TfNSW Reference: SYD26/00022/01
DPHI Reference: SSD-103565216

**REQUEST FOR SECRETARY'S ENVIRONMENTAL ASSESSMENT REQUIREMENTS (SEARS)
MIXED-USE DEVELOPMENT
264A SOUTH STREET, MARSDEN PARK**

Response to SSD-103536711 and SSD-103565216 at 264A South Street, Marsden Park

Attachment 2 – Planning proposal requirements

Figure 1 - Adjacent HDA matters

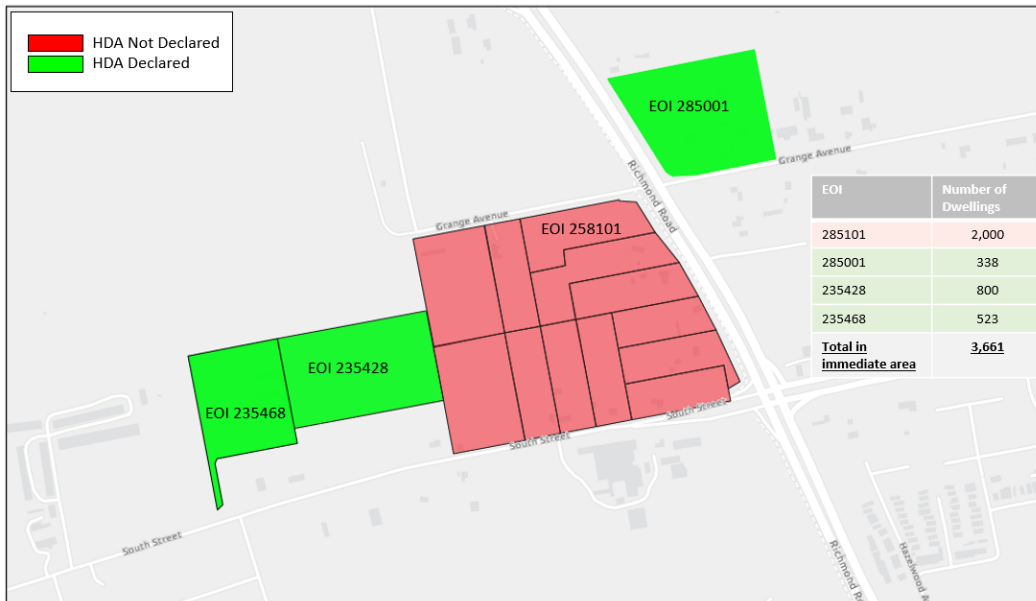
We note that adjacent EOI 258101 (see Figure 1) was not declared by the HDA at its meeting 15 July 2025, with the stated reasons being that:

- i. Objective 2 Identify projects that can be assessed quickly
Criteria 2.1: Largely consistent with development standards
- ii. Objective 3 Drive quality and affordable housing
Criteria 3.2: Well-located - free of specific environmental hazards.

We believe that the subject EOI should not have been declared for the same reasons, as the subject planning proposal is largely inconsistent with development standards, being the zoning of Site 2 as SP2 Infrastructure Community Facilities, and being identified on the Land Reservation Acquisition map for the delivery of these planned facilities. In addition, we believe that this site is not 'well-located - free of specific environmental hazards', due to its location adjacent to a landfill site immediately to the north of the site. In addition, the sites should not have been declared as they also do not meet Criteria 3.1 in being well-located, as they are not in an accessible area.
